CITY OF MONROE PONDEROSA PACIFIC

PONDEROSA
PACIFIC CIVILS
APP# 10914

These plans have been reviewed for compliance with the City of Monroe Public Works Design and Construction Standards and required conditions regarding water, sanitary sewer, storm water management, and streets only. Prior to beginning construction additional approval may be required from other city departments or state or federal agencies.

1 PUMP SYSTEM NOTES
SCALE: NONE

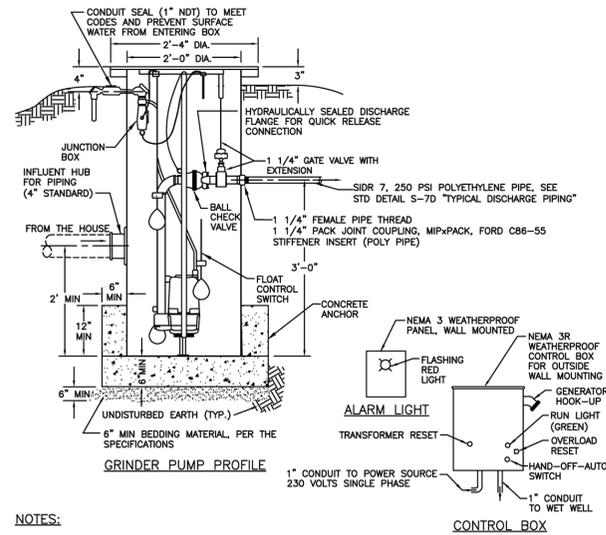
15 Minute test @ 10PSI. Zero Loss- Inspector note.
